PROPOSAL FOR DRAFT AMENDMENTS TO REGULATION No. 48

(Installation of lighting and light-signalling devices)

Transmitted by the Expert from the Working Party "Brussels 1952" (GTB)

Apparent surfaces of lighting units 1 through 11 of an AFS (example)

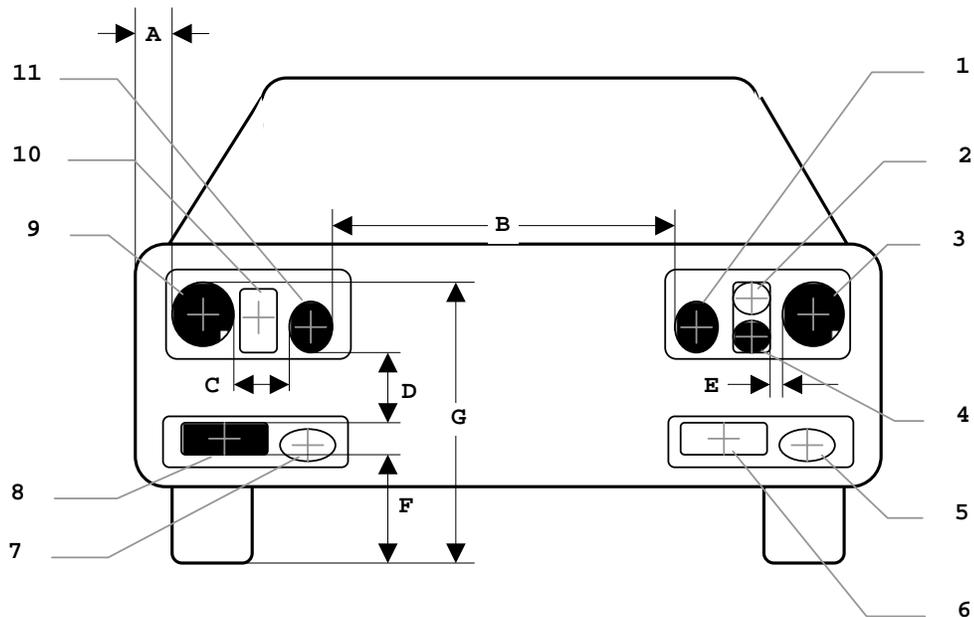
6.20.4.1.1. Two symmetrically placed lighting units shall be positioned at a height in compliance with the requirements of the relevant paragraphs 6.1.4. and 6.2.4., where "Two symmetrically placed lighting units" shall be understood to be two lighting units, one on each side of the vehicle, positioned such that the (geometric) centres of gravity of their apparent surfaces are at the same height and at the same distance from the vehicle's longitudinal median plane within a tolerance of 50 mm, each; their light emitting surfaces, illuminating surfaces, and light outputs, however, may differ.

6.20.4.1.2. *Additional lighting units, if any, on either side of the vehicle shall be positioned at a distance not exceeding 140 mm ^{7/} in horizontal direction (E in the figure) and 400 mm in vertical direction above or below (D in the figure) from the nearest lighting unit;*

6.20.4.1.3. *None of the additional lighting units described in paragraph 6.20.4.1.2. above shall be positioned lower than 250 mm (F in the figure) nor higher than 1200 mm (G in the figure) above the ground;*

the outer edge of the apparent surface of at least one lighting unit on each side of the vehicle shall not be more than 400 mm from the extreme outer edge of the vehicle (A in the figure); and,

the inner edges of the apparent surfaces in the direction of the reference axes shall be not less than 600 mm apart. This does not apply, however, for M₁ and N₁ category vehicles; for all other categories of motor vehicles this distance may be reduced to 400 mm where the overall width of the vehicle is less than 1300 mm."
